Phase specific calculation based on Japanese proposal (OIL#55)

ACEA EV Group

25.06.2014

PHASE SPECIFIC CONSUMPTION FOR OVC-HEV BASED ON THE PROPOSAL FROM JAPAN (OIL#55).

CALCULATION OF ESTIMATED NUMBER OF DRIVEN CD PHASES.

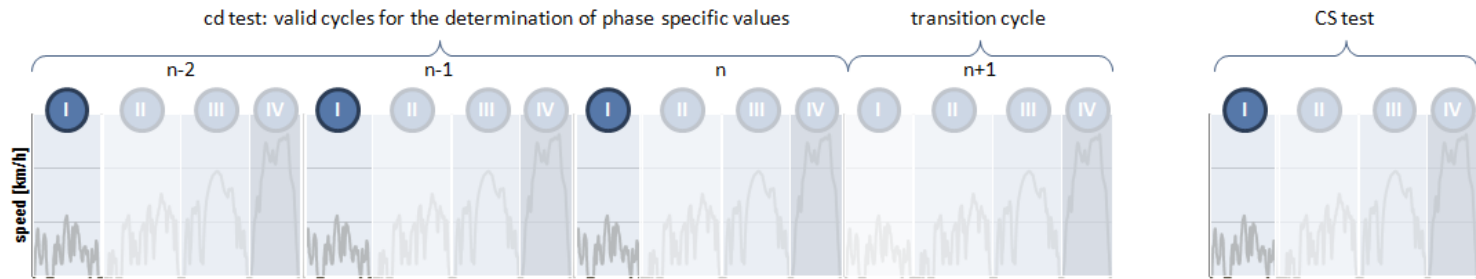
R: ► The number of estimated phases that could be driven consecutively is the basis for all following phase specific calculations.

R: ► The approach can only be applied to vehicles that are able to drive the whole first cycle in charge depleting because the transition cycle has to be excluded for the determination of the electric consumption to calculate the estimated electric range for the specific phase.

Q: ► How to handle with vehicles that are able to drive a transition cycle only?

Q: ► How big is the impact of the "cold start" conditions if only one cycle can be used because the second one is a transition cycle?

Japanese answer: Proposed calculation formula doesn't take care of such a vehicle. Thank you for your feedback. Need to consider the alternative method for those vehicles.

ACEA: In that case a proposal could be to drive each phase separately. → higher test burden for such kind of vehicles

Japanese answer: It depends on the system, however, it has negative impact on performance value. It's OK for us to have an option to run the consecutive each phase test (L-L-L-L..., M-M-M-M...,) as an option.

CALCULATION OF ESTIMATED ELECTRIC RANGES.

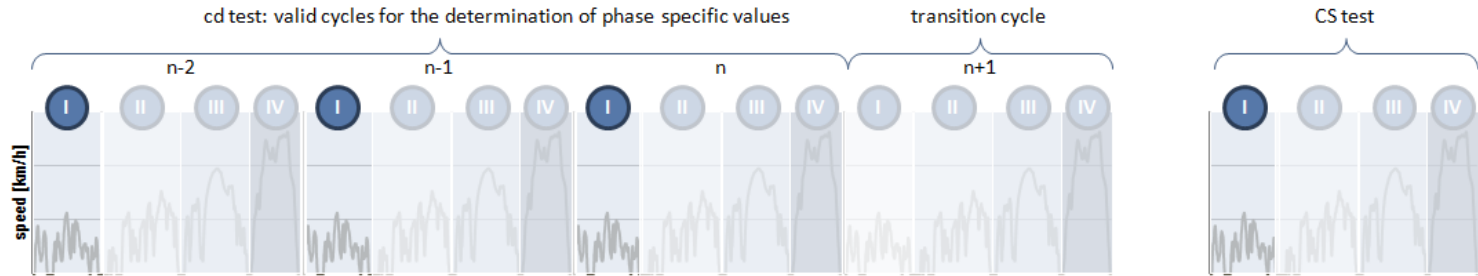
R: ► The $CO_{2,CDavg,Low}$ will always be zero if there is no power-triggered engine start because the transition cycle is excluded. That means $EAER_m$ equals $R_{CDC,m}$!

R: ► RCB-correction for each phase in charge sustaining is necessary! That is not required in the GTR now!

Japanese statement: Not available.

ACEA: The calculation of RCDa is sufficient. The calculation of EAER and R_{CDC} has no additional value.

Japanese answer: If no correction is necessary for whole cycle, no correction is required for each phase as basis. It's OK to allow manufacturer to develop each phase correction factor.

ACEA: If the RCB correction is not required because the test is within the tolerance, the low and mid CO_2 will be lower and the high and extraHigh CO_2 will be higher than the value that would be determined by driving consecutive each phase cycles.

→ First solution: Each phase measurement. → Disadvantage of higher test burden. → Is not recommended by the ACEA.

→ Second solution: An approach for each phase RCB-correction is to use the cycle energy. The energy demand over the whole cycle and the energy demand over each phase leads to an each phase percentage that can be used to calculate the each phase consumption by multiplication of each phase percentage and whole cycle consumption (nearly SOC neutral).

CALCULATION OF ESTIMATED ELECTRIC CONSUMPTION.

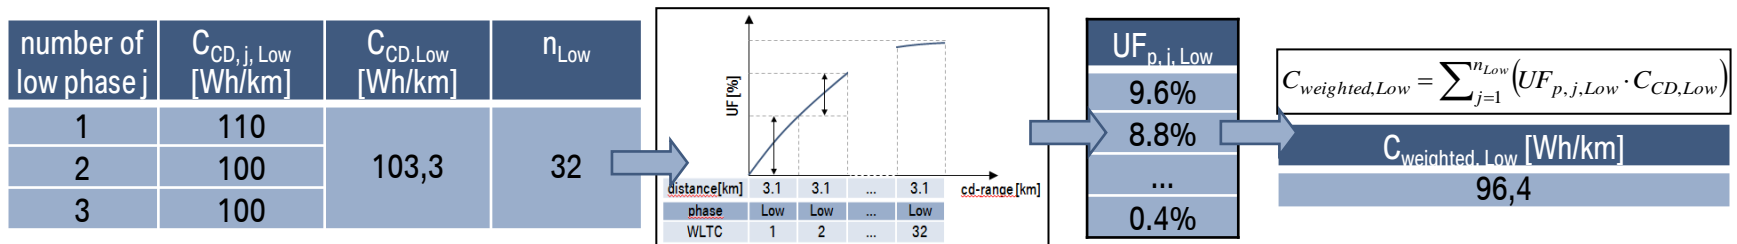
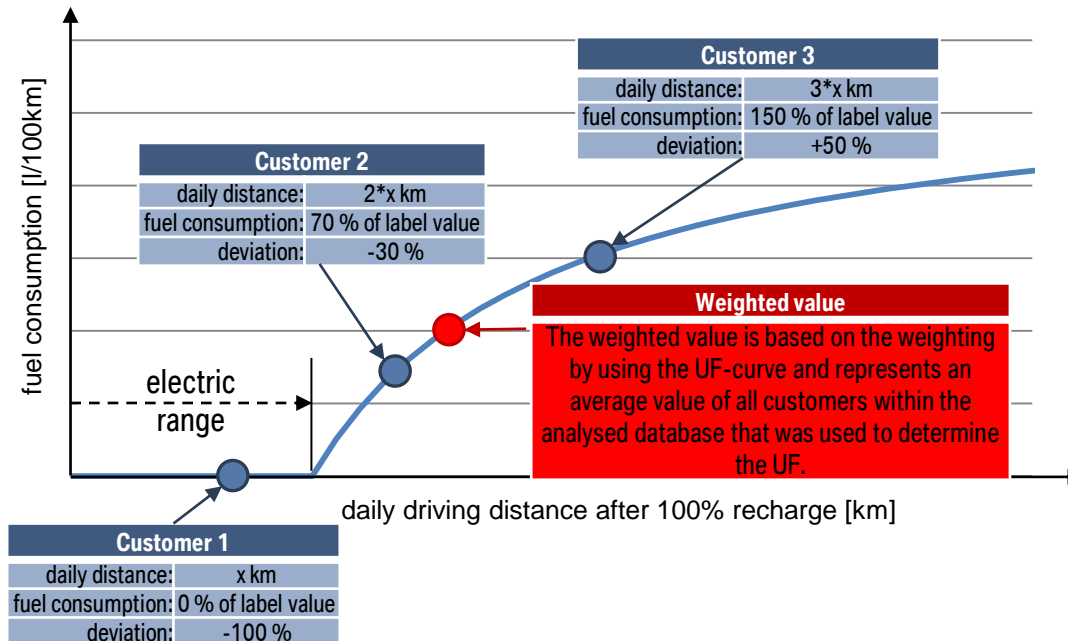
R: ► Is it valid to use the same UF curve for the weighting of each phase consumptions or do we need more criteria concerning the analysis of databases to determine a UF curve for the low, mid, high and exHigh – phase (e.g. a filter that distinguishes between urban and non-urban drive)!

Japanese answer: We've made a decision to adopt regional UF for OVC-HEV calculation. Each region can adopt their own UF for also phase specific calculation. (JPN has only one UF and this UF is used for all kinds of calculation)

ACEA: UF-weighted values are only made for the calculation of average fleet values. Each individual customer consumption hardly depends on the average daily driven distance.

ACEA proposes to delete the calculation of weighted each phase values.

WEIGHTED VALUES ARE **UNSUITABLE** FOR CUSTOMER INFORMATION; FOR WHOLE CYCLE VALUES AS WELL AS FOR EACH PHASE VALUES.

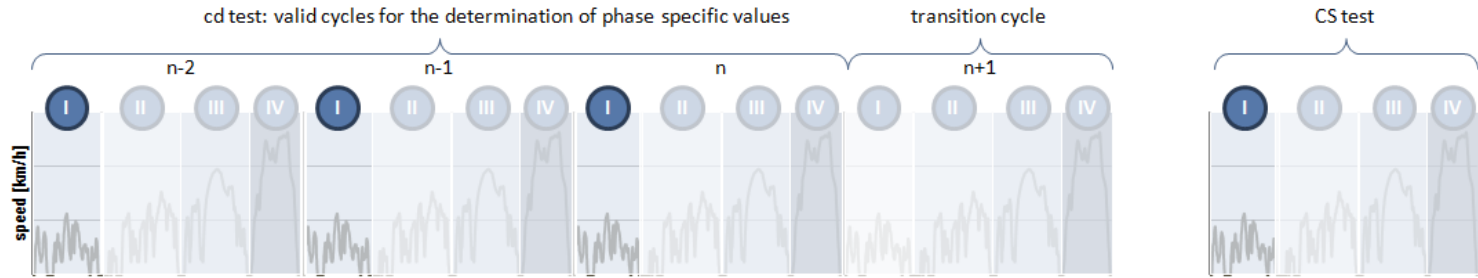
R: ► The figure shows the dependence from the daily driven distance of the customer concerning the fuel and electric consumption.

R: ► A weighted value is made to represent an average value for a fleet of vehicles, that can be used as a homologation value.

► Using of separated values for charge depleting and charge sustaining mode for customer information.

CALCULATION OF ESTIMATED FUEL CONSUMPTION AND CO₂.

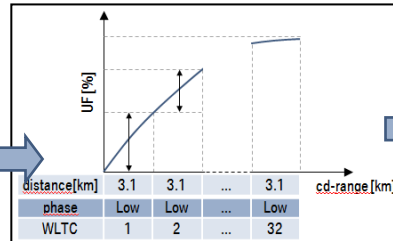
► The recommendation from ACEA is to delete the calculation for the weighted each phase fuel consumption (as well as for the weighted electric consumption) because weighted values are not suitable for customer information (see slide 5 and 6).

3 Phase based calculation: EAER

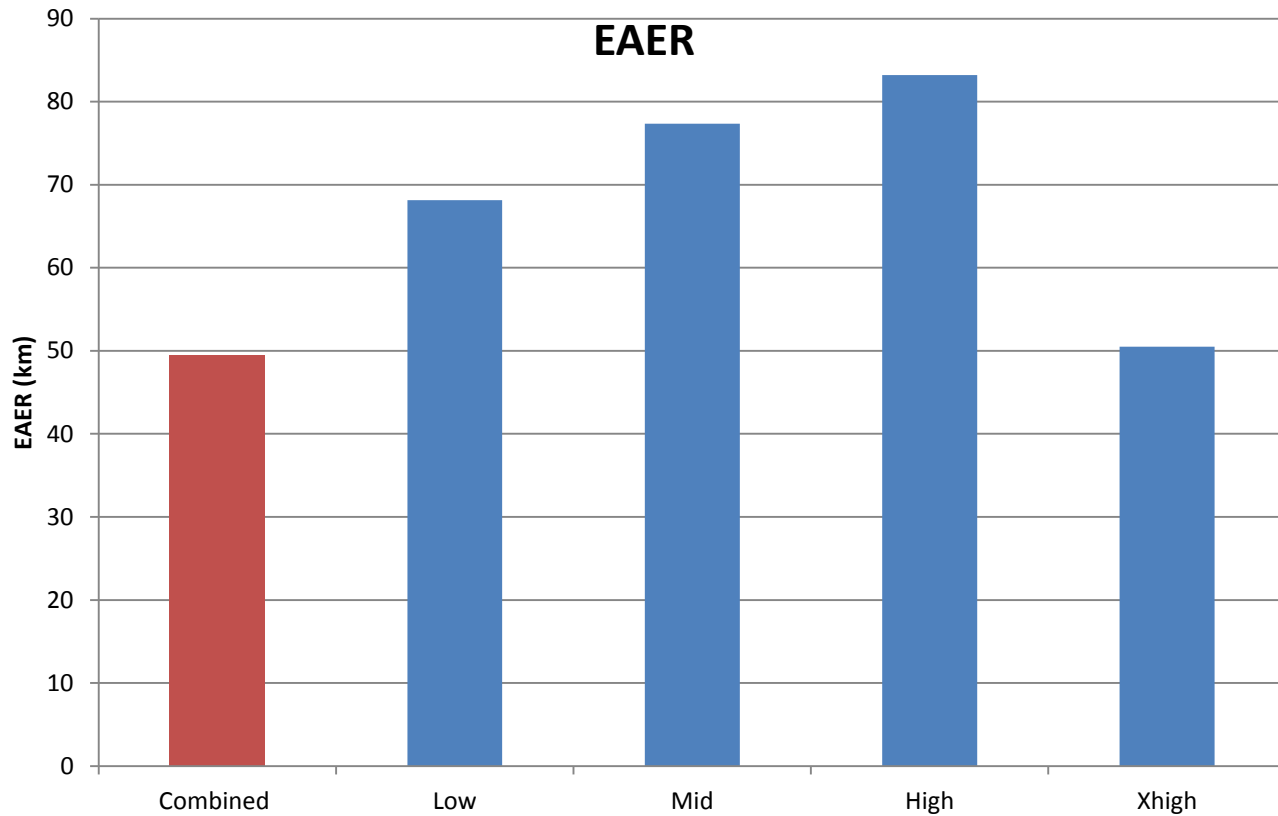
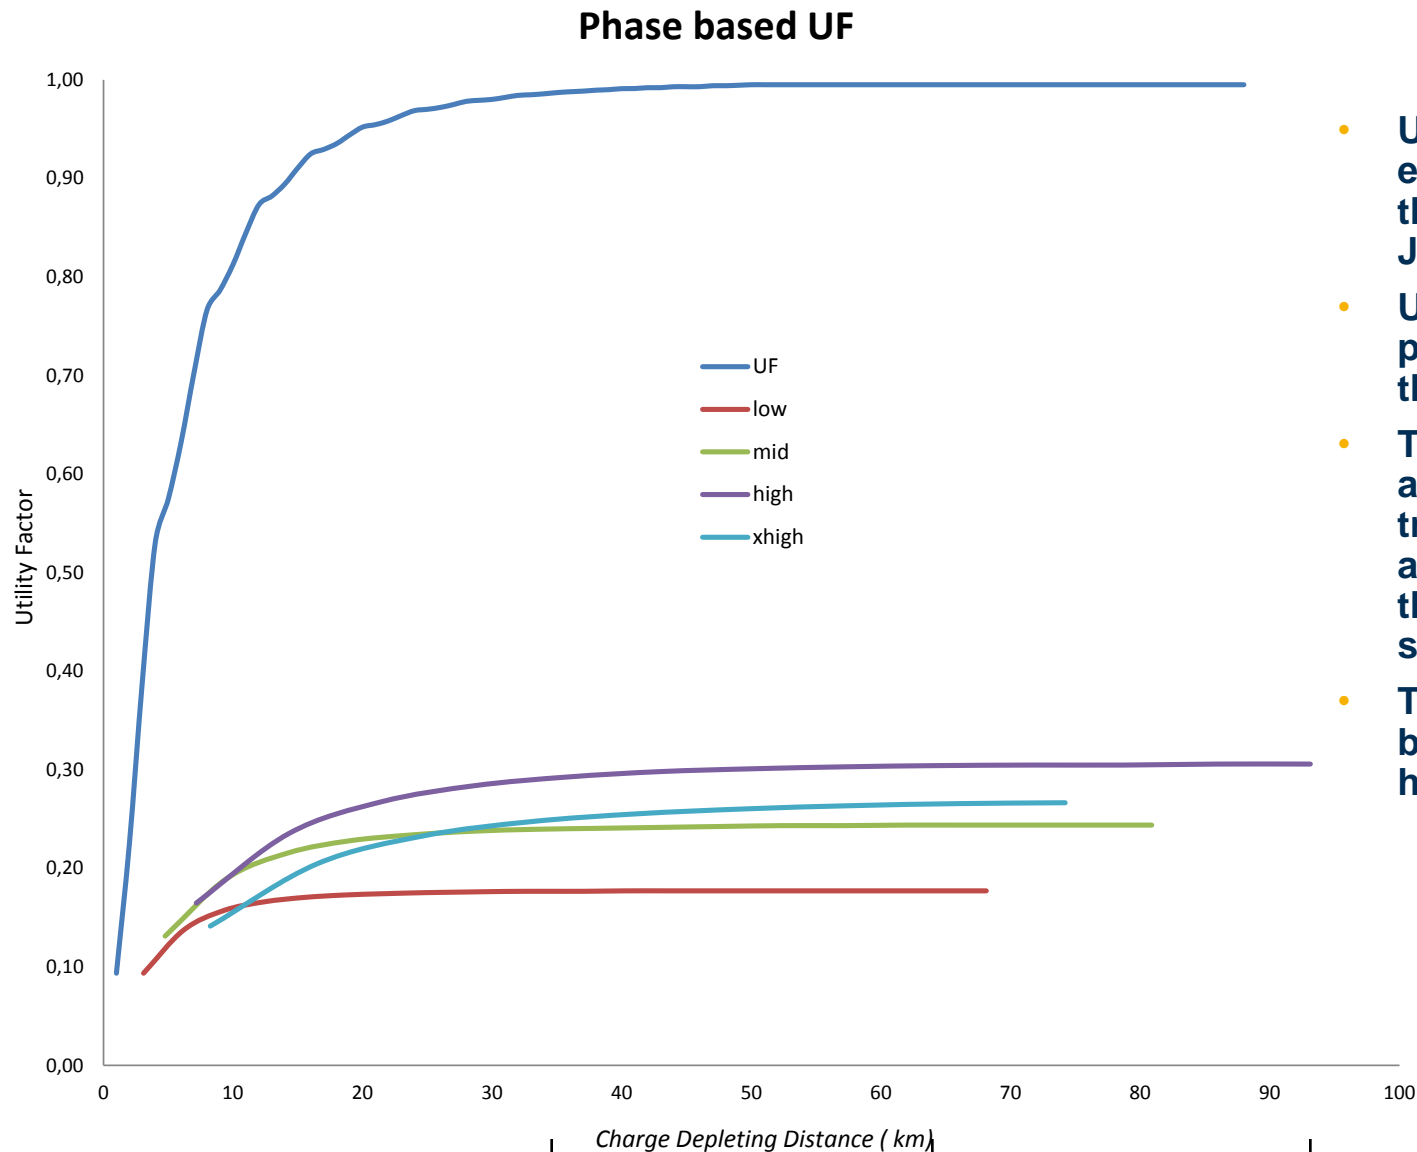
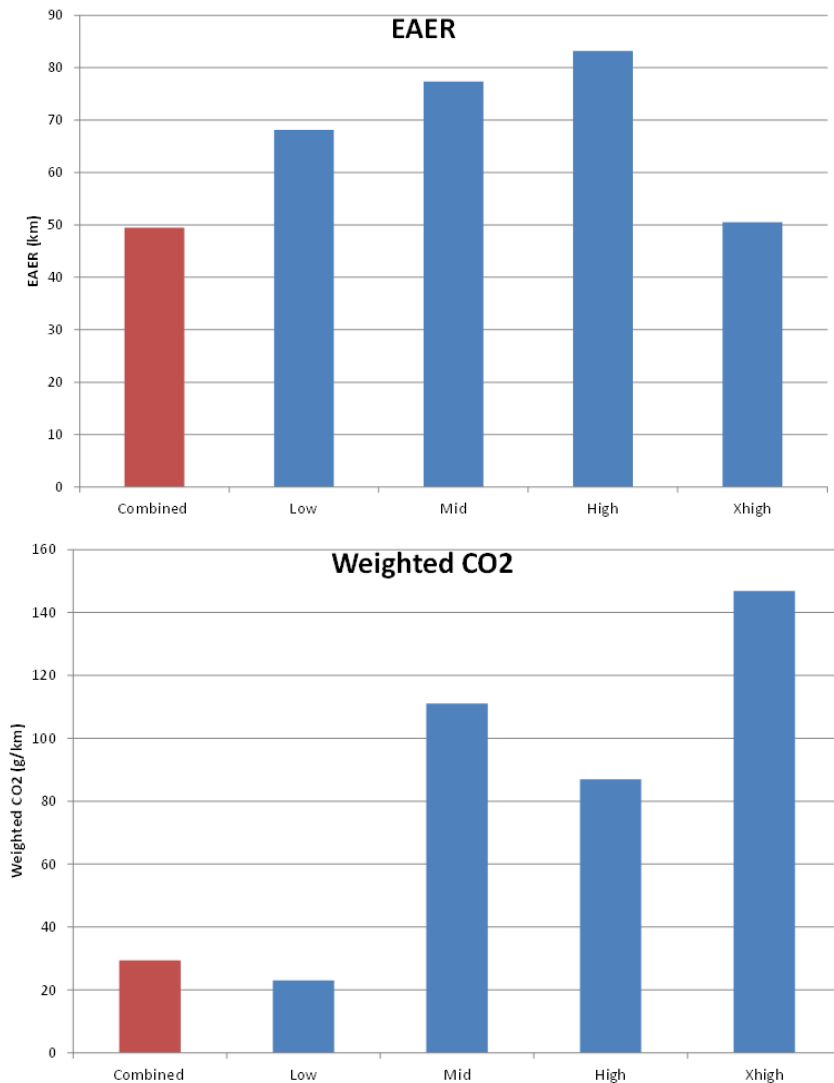
- UF for each phase is estimated according to the method proposed by Japan.
- UF estimation for each phase is incoherent with the global utility factor.
- The UF depends on the average distance traveled but not on average speed. Hence the UF for each phase should not vary much.
- The high phase has better UF than the 'extra high' phase.

3 Phase based calculation: Weighted CO2 value

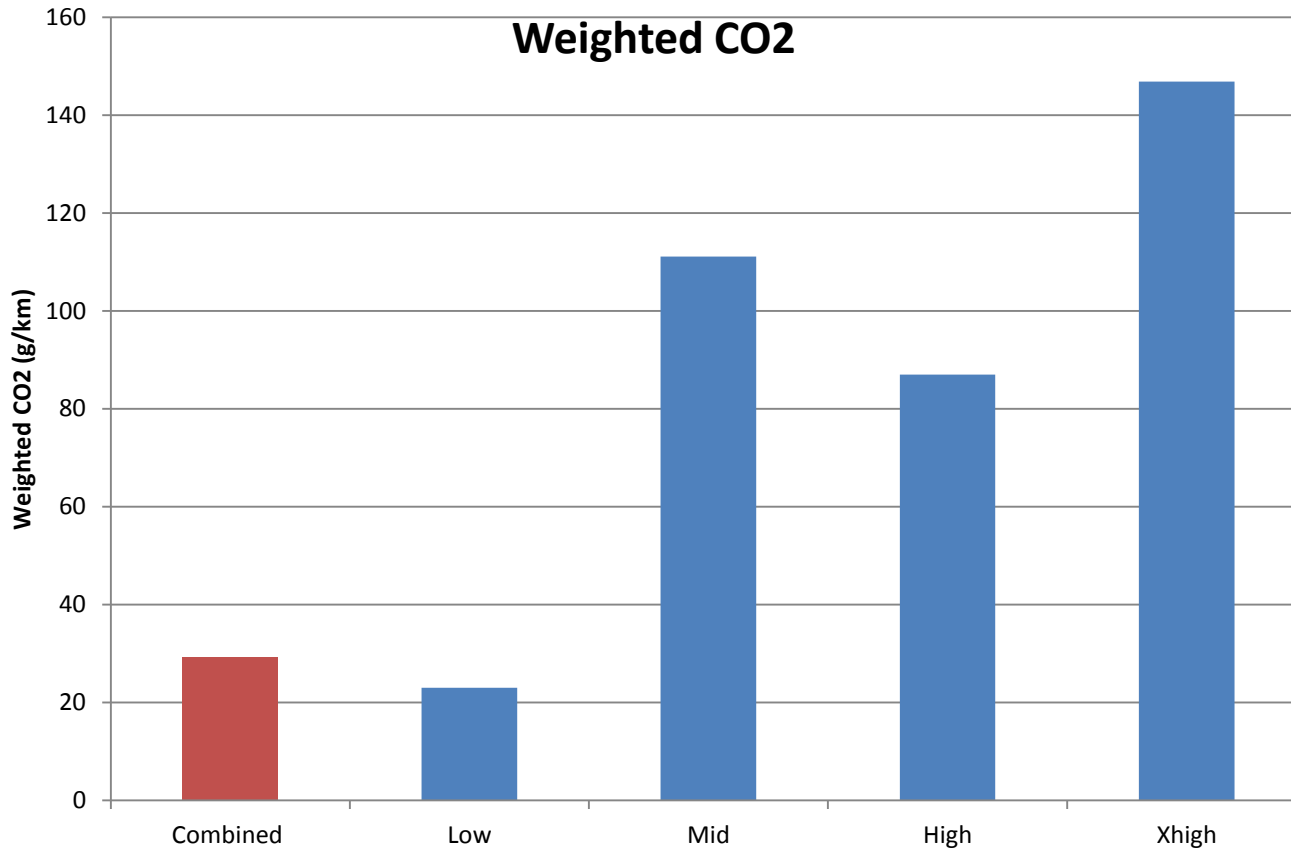
Contrary to EAER the CO2 value of combined cycle is much lower than the estimated value for each individual cycle.

In the calculation the average CD CO₂ value from the real test (e.g. based on 3 real driven low phases) is assumed to be representative for the estimated number of cycles that would be driven in a single cycle test.
